SUBJECT: TRANSPORTATION AND LAND MANAGEMENT AGENCY/TRANSPORTATION:
Approve and Execute Contract Change Order No. 7 – Between the County of Riverside and Riverside Construction Co., for the Construction of Avenue 66 at SR-111 and Union Pacific Railroad Grade Separation Project near the Community of Mecca, District 4. [\$963,106 Total Cost – Coachella Valley Water District 100%]

CHANGE ORDER REPORT
(Avenue 66 at SR-111 and Union Pacific Railroad Grade Separation)

Contract Change Order No. 7

CONTRACT: Avenue 66 At SR-111 and Union Pacific
Railroad Grade Separation Project

PHASE 1A WATERLINE PLAN
SCALE: 1" = 50'

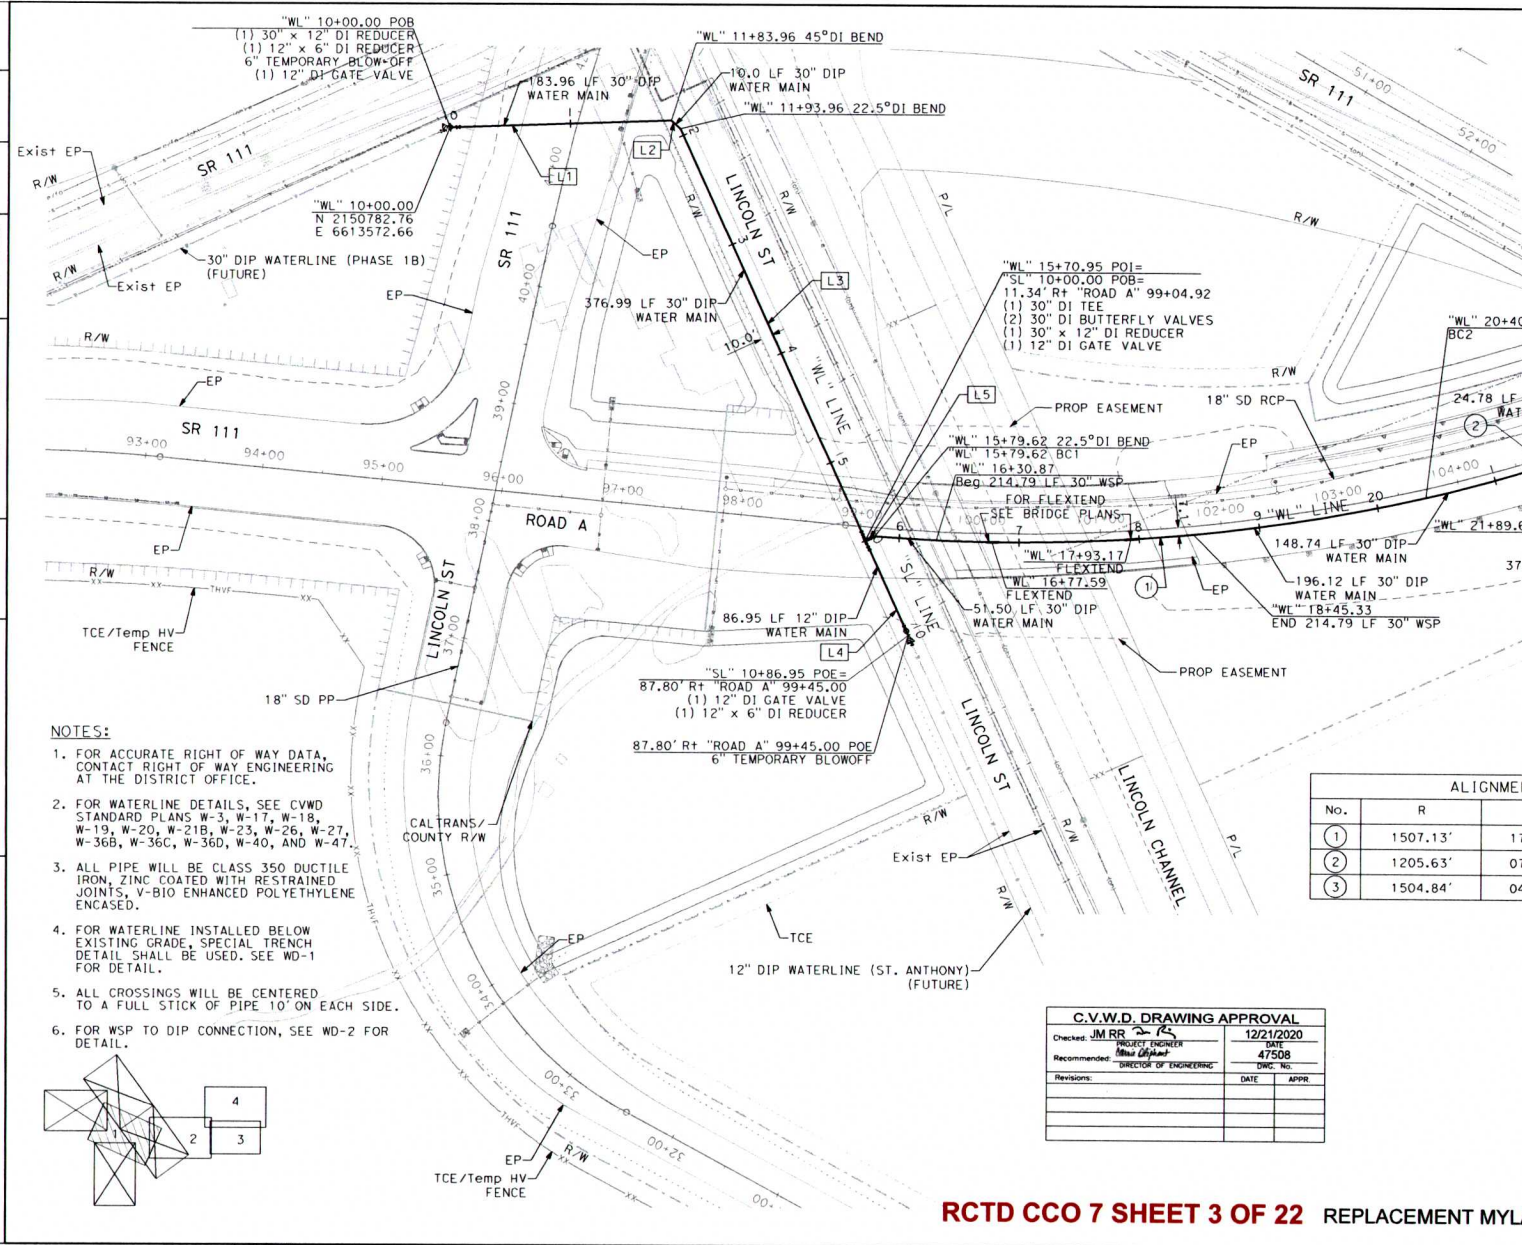
Remove sheets W-1, W-2, W-3, W-4, WP-1, WP-2 and WD-1 from the bid plans and replace with sheets 3 through 10 of this change
order. Contractor to perform all work associated with these plans. As shown on the attached plans, change routing, upgrade pipe to
Class 350 Ductile Iron Pipe, zinc coated, with V-Bio Enhanced Polyethylene, and other associated work at the unit prices shown
below.

Remove sheets W-1, W-2, W-3, W-4, WP-1, WP-2 and WD-1 from the bid plans and replace with sheets 3 through 10 of this change order. Contractor to perform all work associated with these plans.

- NOTES:**
1. FOR ACCURATE RIGHT OF WAY DATA, CONTACT RIGHT OF WAY ENGINEERING AT THE DISTRICT OFFICE.
 2. FOR WATERLINE DETAILS, SEE CWWD STANDARD PLANS W-3, W-17, W-18, W-19, W-20, W-21B, W-23, W-26, W-27, W-36B, W-36C, W-36D, W-40, AND W-47.
 3. ALL PIPE WILL BE CLASS 350 DUCTILE IRON, ZINC COATED WITH RESTRAINED JOINTS, V-BIO ENHANCED POLYETHYLENE ENCASED.
 4. FOR WATERLINE INSTALLED BELOW EXISTING GRADE, SPECIAL TRENCH DETAIL SHALL BE USED. SEE WD-1 FOR DETAIL.
 5. ALL CROSSINGS WILL BE CENTERED TO A FULL STICK OF PIPE 10' ON EACH SIDE.
 6. FOR WSP TO DIP CONNECTION, SEE WD-2 FOR DETAIL.
